12 PIMMOG STREET
QUAY CHASE VILLAGE H.D.

From: Silver, Joshua
Sent: Friday, December 20, 2013 11:10 AM
To: 'Lila Fendrick Landscape Architecture'
Subject: RE: 12 Primrose Fence

From: Lila Fendrick Landscape Architecture <team@fendrickdesign.com>
Sent: Friday, December 20, 2013 10:19 AM
To: Silver, Joshua
Subject: 12 Primrose Fence
Attachments: Fencing Height.pdf

SUBJECT: Historic Area Work Permit #647915, fence replacement and tree removal

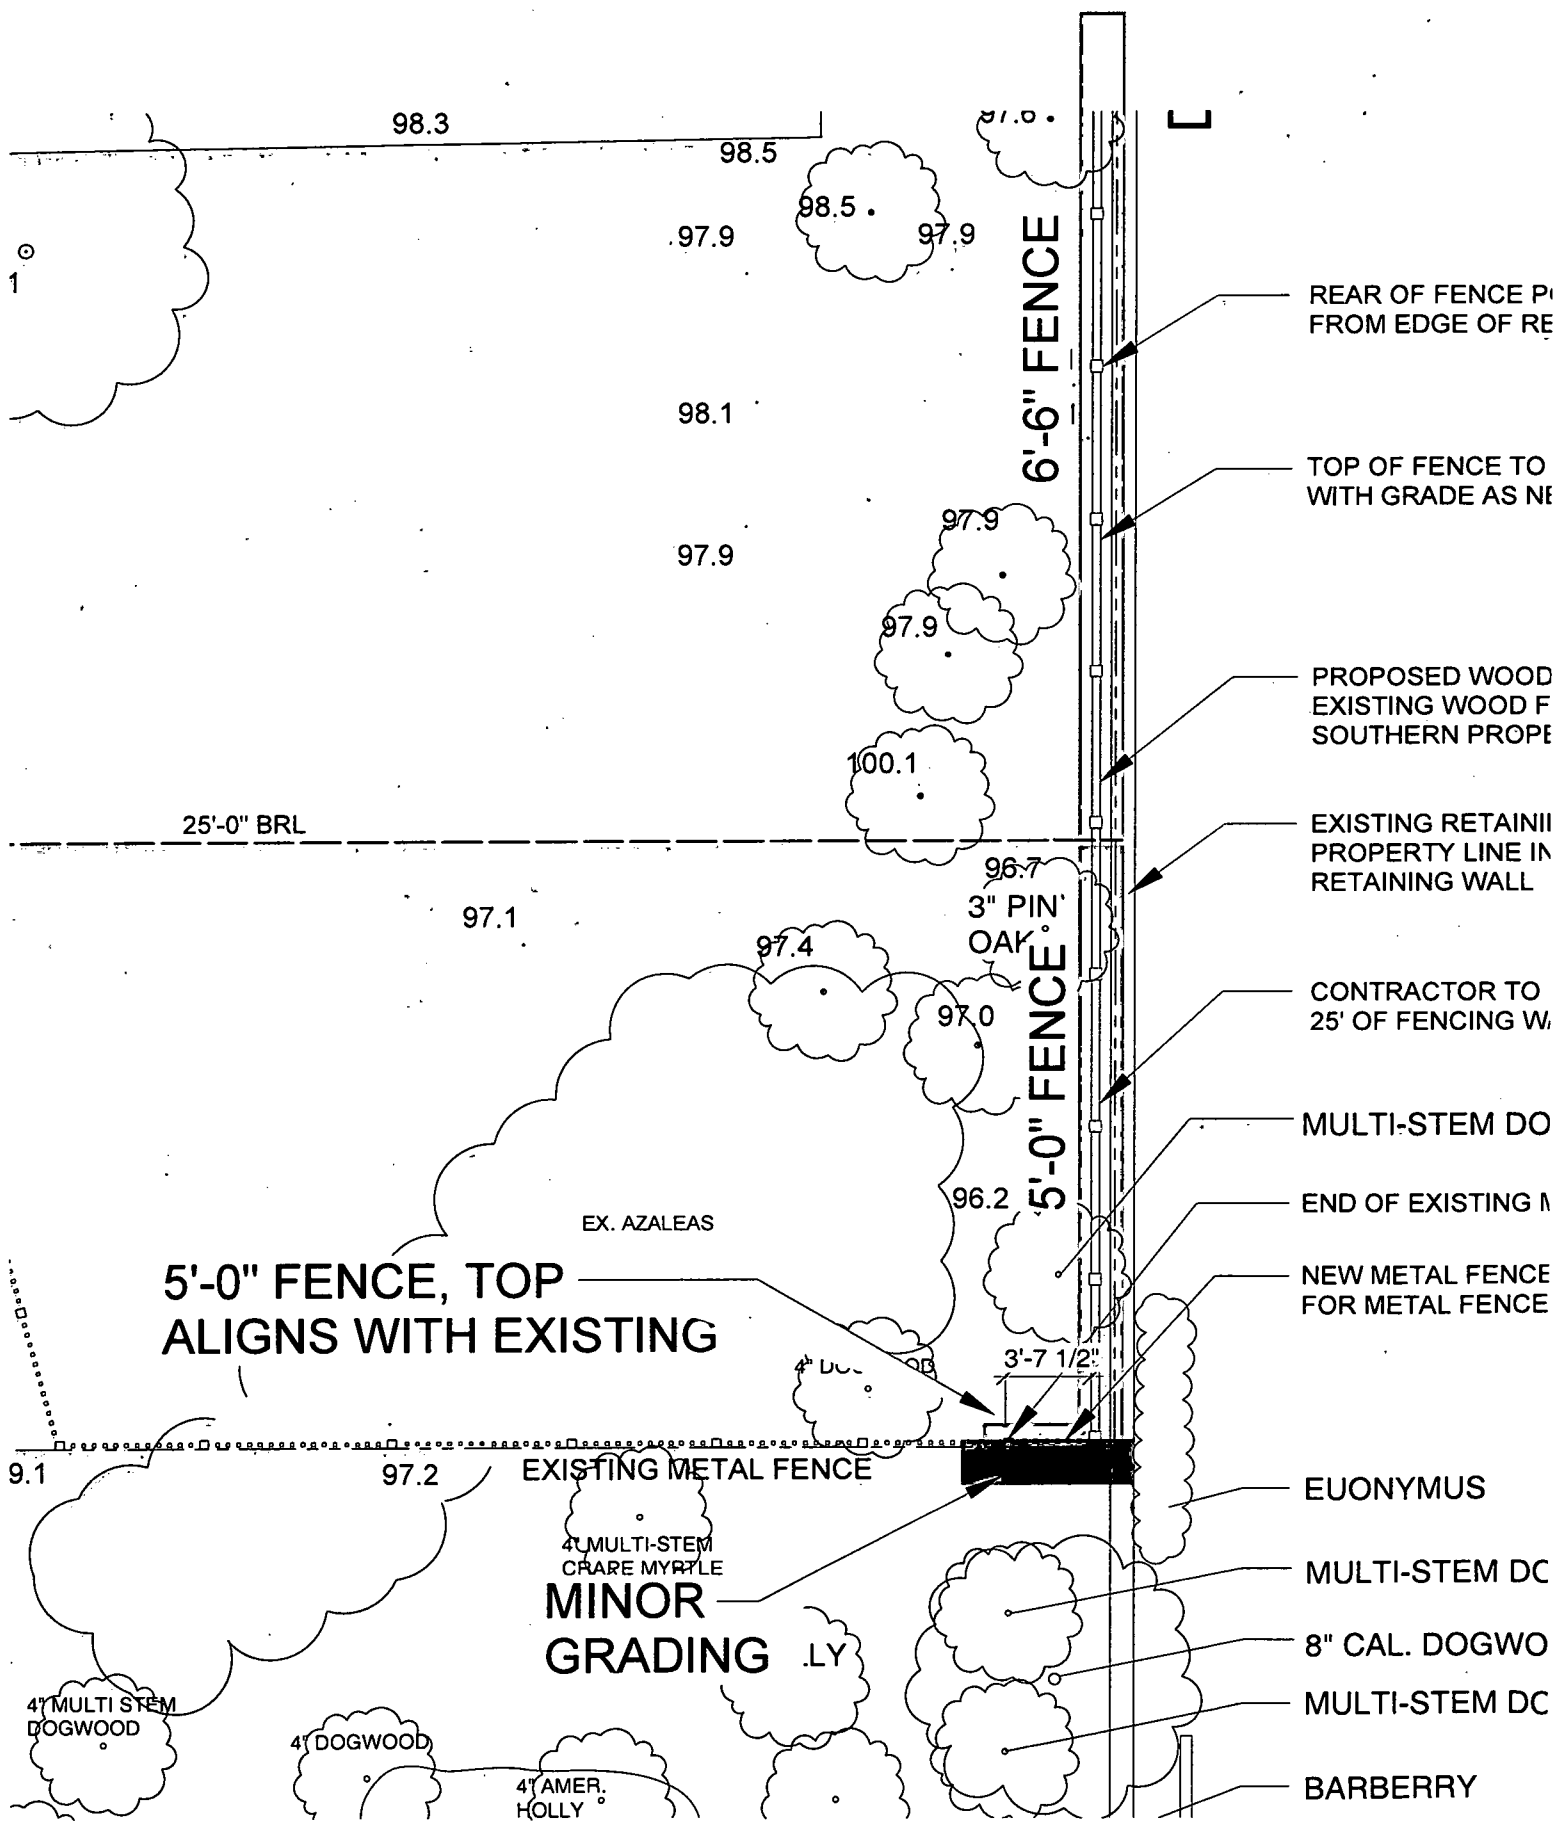
Attached is a diagram showing where this change occurs. Starting at the 25' BRL the fence will drop to a shorter height of 5'-0" (lower than what was approved by HPC) and remain at that height until it meets the metal fencing panel that was permitted. The grade at the corner will be mildly adjusted to make sure that the new 3'-7 1/2" wide panel is level with the existing metal fence, but is not any higher than 5'-0" above grade.

Thanks for the update. Please proceed with the requested revision as shown on the attached plan. No further review by the HPC is required.
